Access Compliance Report

Public Rights-of-Way

(Curb Ramps)

Intersection ID: 9461	Main Street: BANCROFT_ST	Cross Street: W_28TH_ST	Location: E
ADA ID: 05F88883B1EB	Ramp Type: Combination2	Initial Pass/Fail: Fail	Overall Compliance: No
Severity Score: 13.75			
Codes/Mitigation Info/Possible Solution		Field Measurements/Component Compliance

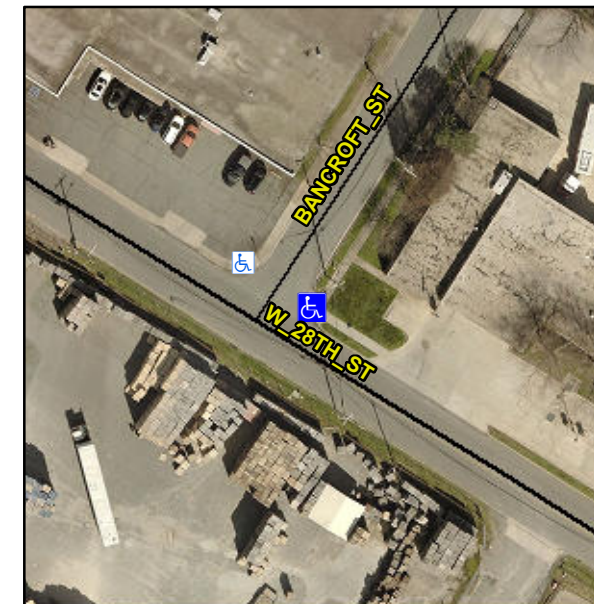
RT RP < 5%

Not Found, R304.2.2, R304.5.3

Remove & Replace Entire Ramp.
